Re: Affected Property Assessment Report, Former Operating Plant, Frisco Recycling Center,
Frisco, Collin County, Texas (Agreed Order Docket No. 2011-1712-IHW-E);
City of Frisco comments

This submittal is the City of Frisco's (the City's) comments on the Affected Property Assessment Report (APAR) submitted by Exide Technologies (Exide) for the former Exide battery recycling facility in Frisco, Texas. This area is also known as the Bowtie Parcel in the context of the Exide – City of Frisco Settlement Agreement that required closure of the Exide facility. The adjacent J Parcel is being purchased by the City for future development following remediation by Exide under a Texas Commission on Environmental Quality (TCEQ) Voluntary Cleanup Program (VCP) application.

COMMENTS ON APPENDIX 7 OF AFFECTED PROPERTY ASSESSMENT REPORT,
FORMER OPERATING PLANT, FRISCO RECYCLING CENTER, FRISCO, COLLIN COUNTY,
TEXAS (AGREED ORDER DOCKET NO. 2011-1712-IHW-E), PASTOR, BEHLING &
WHEELER LLC, DATED 7/10/2013

Figure 1
Former Exide Technologies

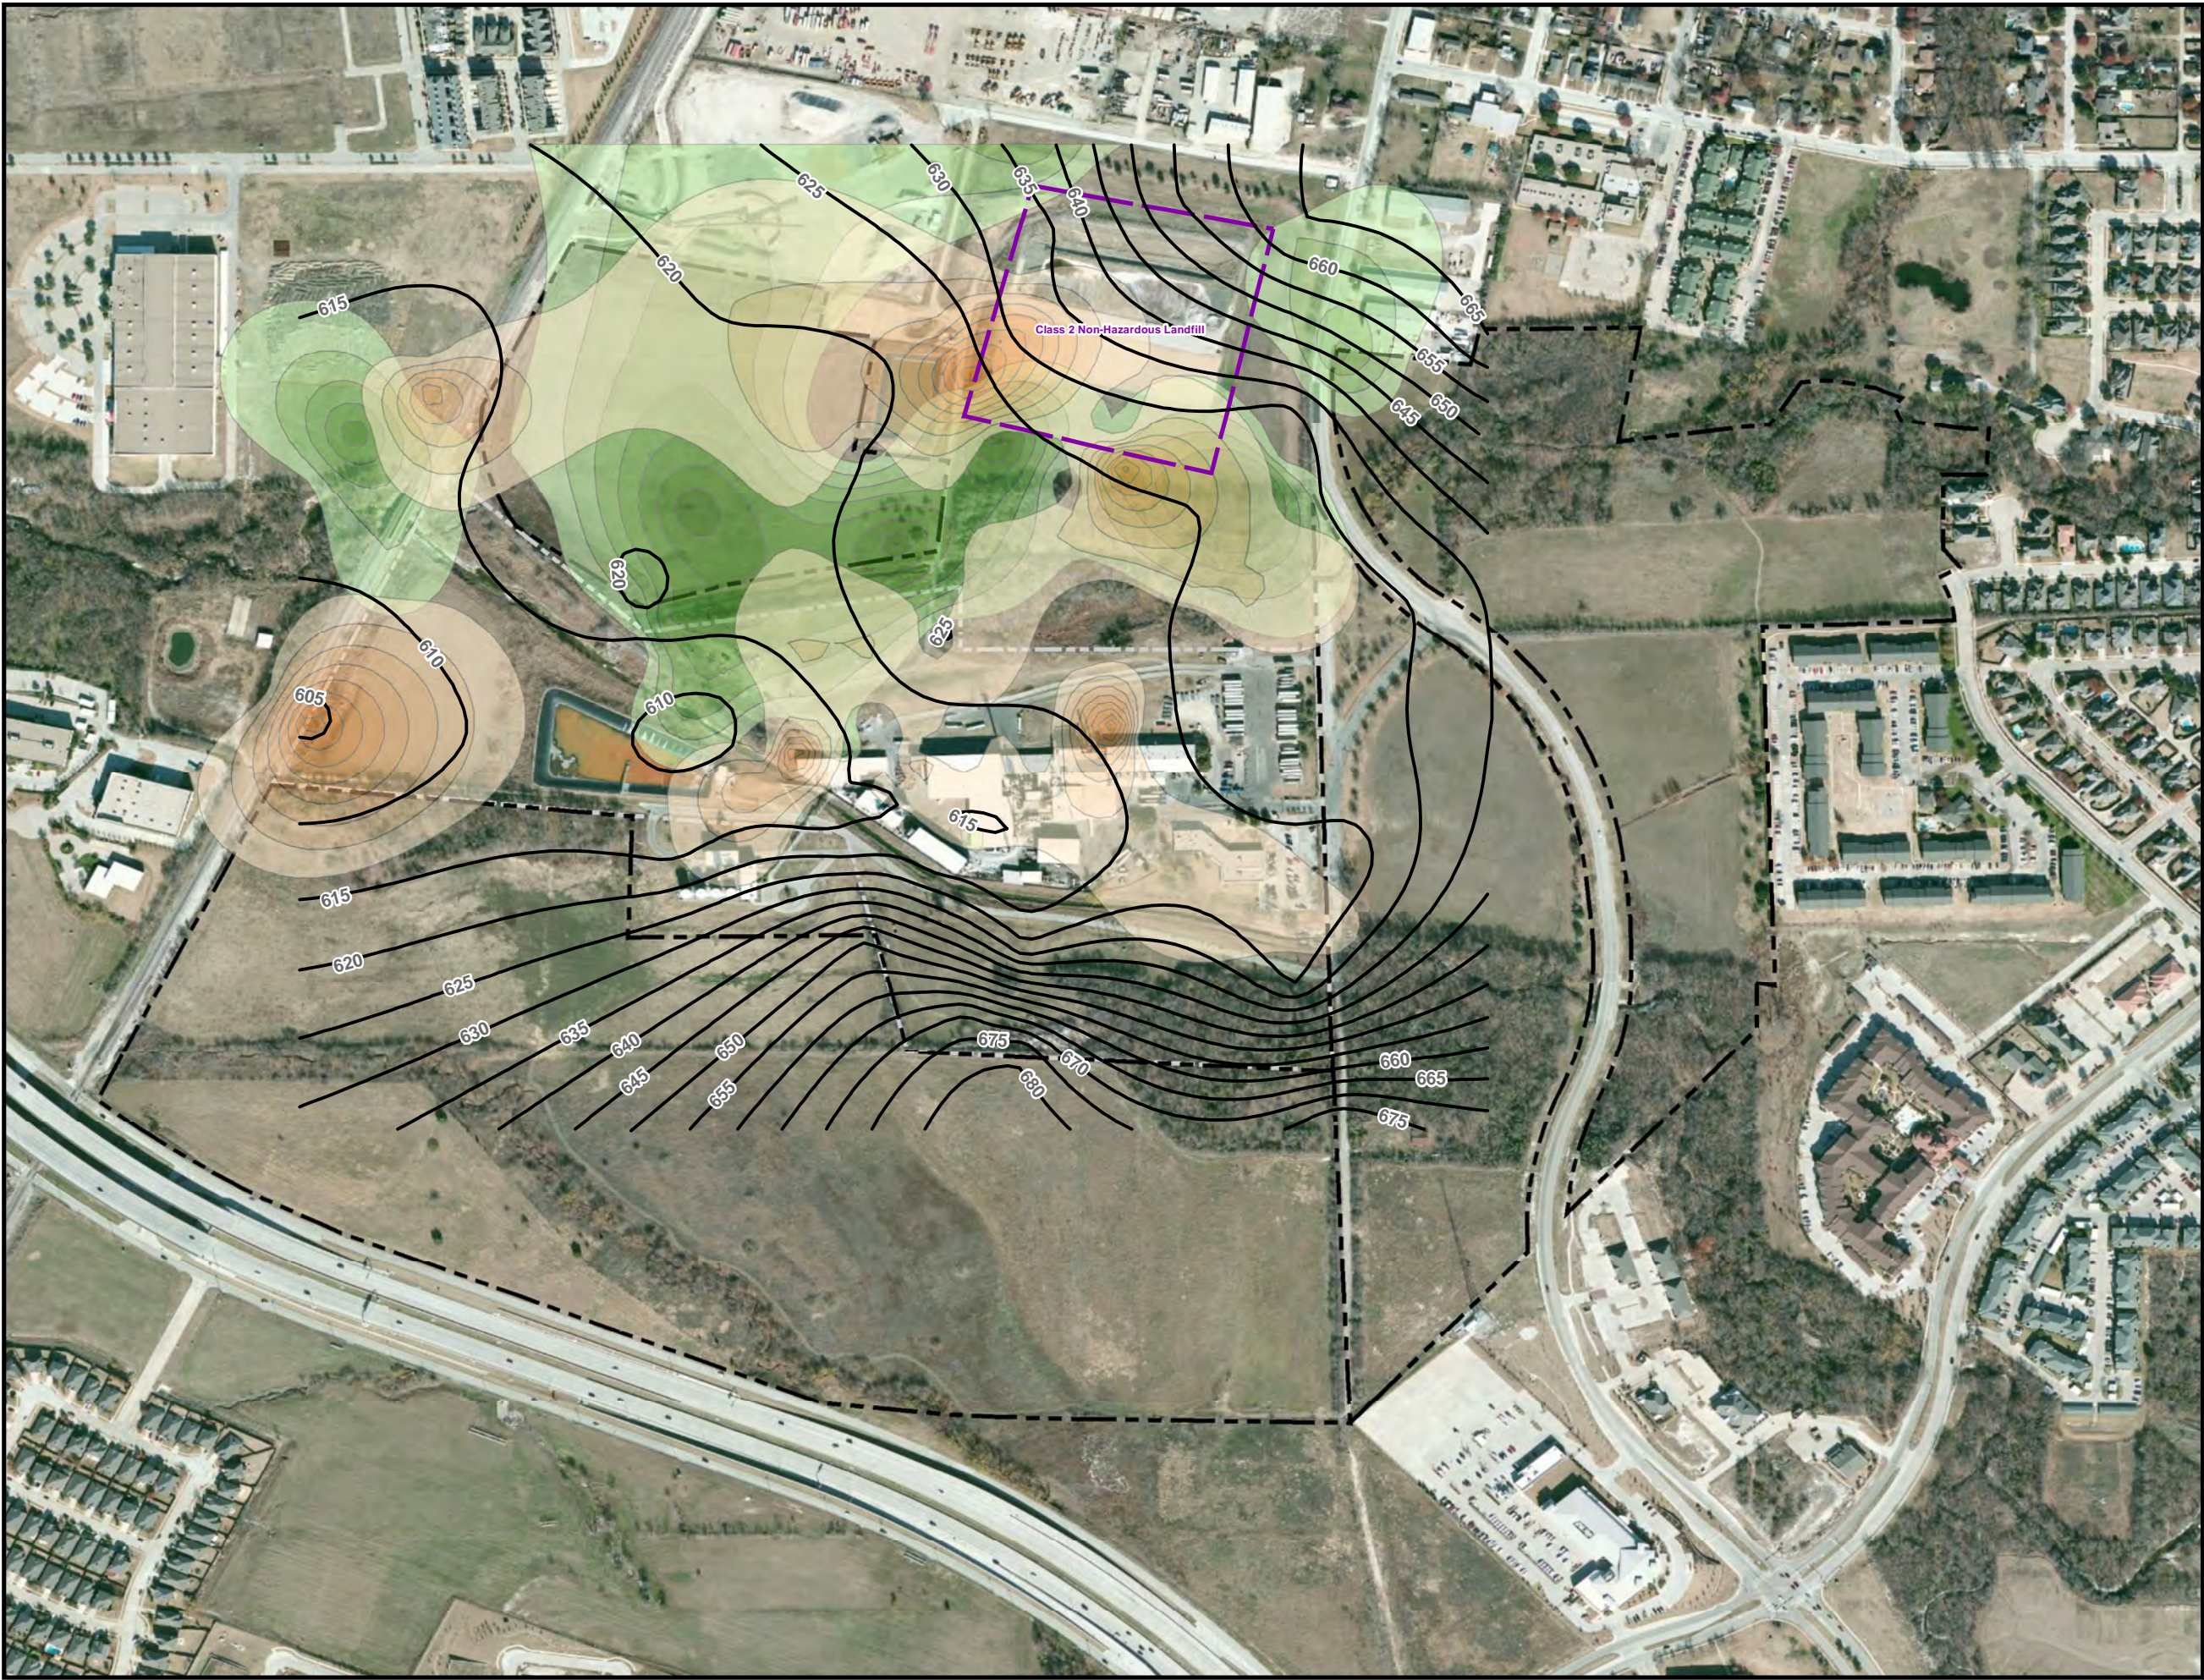
These alluvial deposits consist of unconsolidated soils with grain sizes ranging from silty clays to sandy gravels. This unit is present and is continuously saturated across the northern and eastern portions of the site. Figure 1 (attached) provides a map of the apparent extent of this unit based on an overlay of the extent of the clayey gravels and extent of the gravels and sands as mapped by PBW. Figure 2 documents the saturated thickness of the unit in and around the former Exide operating facility.

Figure 4
Aerial Photograph
1942

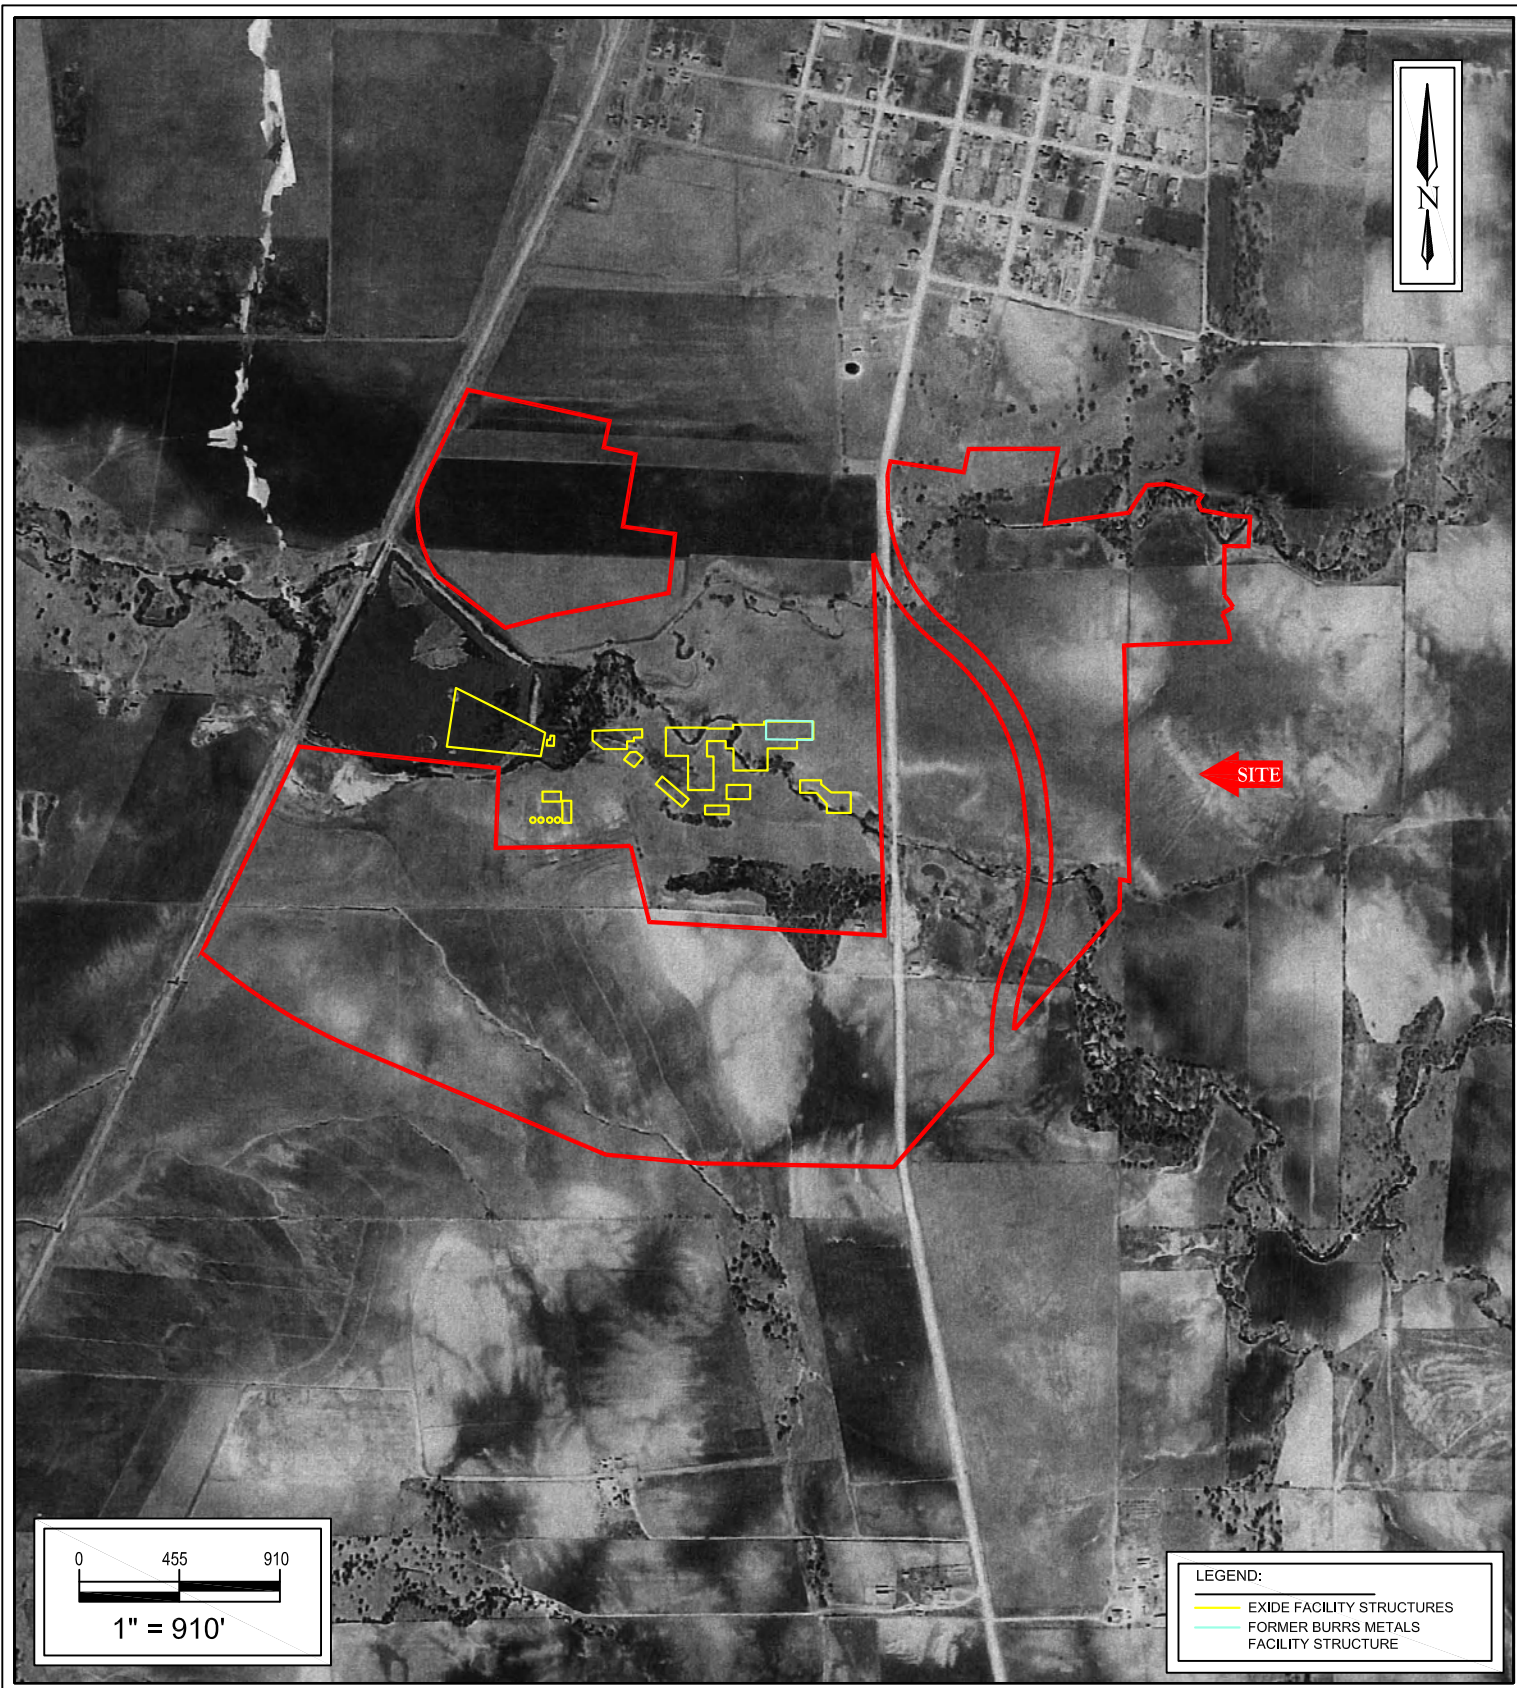
Because the Exide facility extends over the former channel of Stewart Creek and its northern tributary (the Slag Landfill and North Disposal Area extend over the northern tributary's former channel as well), a large percentage of the central and western portions of the operating facility is situated on fill. In some areas the fill is relatively deep and is saturated. For example, MW-30 was installed through (or very close to) the former Stewart Creek channel. The boring log for MW-30 reports slag and lead were found at a depth of 28 feet below grade at that location. Figure 3 depicts the possible extent of fill at the former operating facility. The former stream channels are also depicted on Figures 1-3, and an overlay of the Exide facility on a 1942 aerial photograph is provided as Figure 4.
